**World Forum for Harmonization of Vehicle Regulations****Working Party on Passive Safety Provisions****Seventieth session**

**UN Regulation No. 16 (Safety-belts)****Proposal for Supplement 4 to the 08 series of amendments to  
UN Regulation No. 16 (Safety-belts)****Submitted by the expert from the European Association of Automotive  
Suppliers\***

Annex 17, Appendix 2, Figure 9, amend to read:

"Figure 9

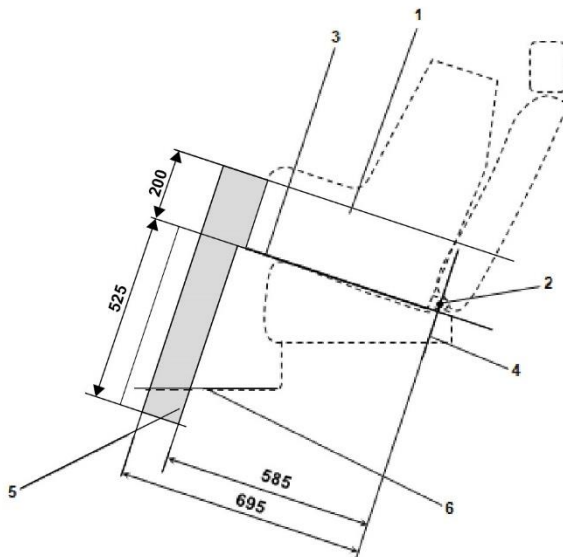
2. In our proposal, the top surface of the support leg volume has been raised upwards to match the support leg opening in the ISO/F2X envelope to facilitate more space for support legs. Increasing the height of the support leg volume would improve the compatibility between the support leg volume and the ISO envelopes. This would be particularly useful for large rearward facing CRS designs with support legs.

**Side view of the i-Size support leg installation assessment volume for assessing compatibility of the i-Size seating positions with support legs of i-Size child restraint systems**

1. Child Restraint Fixture (CRF).
2. ISOFIX low anchorages bar.
3. Plane formed by the bottom surface of the CRF when installed in the designated seating position.
4. Plane passing through the lower anchorage bar and oriented perpendicular to the median longitudinal plane of the CRF and perpendicular to the plane formed by the bottom surface of the CRF when installed in the designated seating position.
5. i-Size support leg installation assessment volume representing the geometrical boundaries for an i-Size ISOFIX child restraint system support leg.
6. Vehicle floor.

"Figure 10

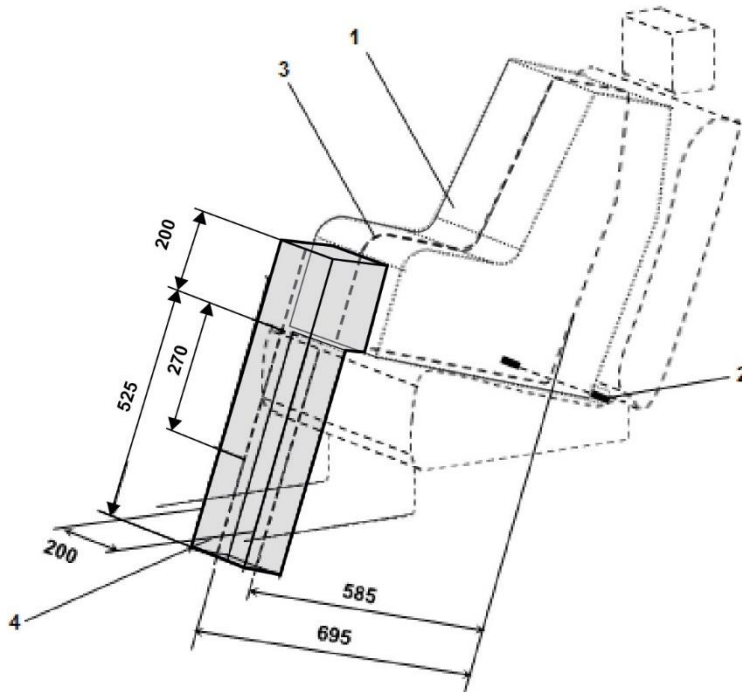
Annex 17, Appendix 2, Figure 10, amend to read:

**3D view of the i-Size support leg installation assessment volume for assessing compatibility of the i-Size seating positions with support legs of i-Size child restraint systems**

1. Child Restraint Fixture (CRF).
2. ISOFIX low anchorages bar.
3. Median longitudinal plane of the CRF.
4. i-Size support leg installation assessment volume.

Figure  
ISO/...

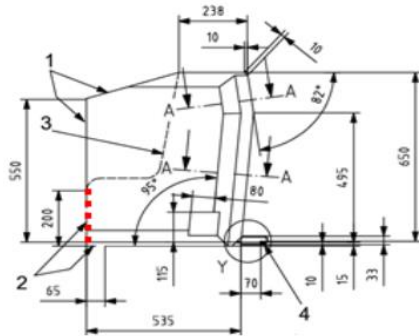
1. UN Regulation No. 16 defines the envelope dimensions of ISO/R2 and ISO/F2X CRF envelopes. The dashed line 2) represents the area where a support leg or similar may protrude. For the ISO/F2X envelope, this is indicated with a height of 200 mm.
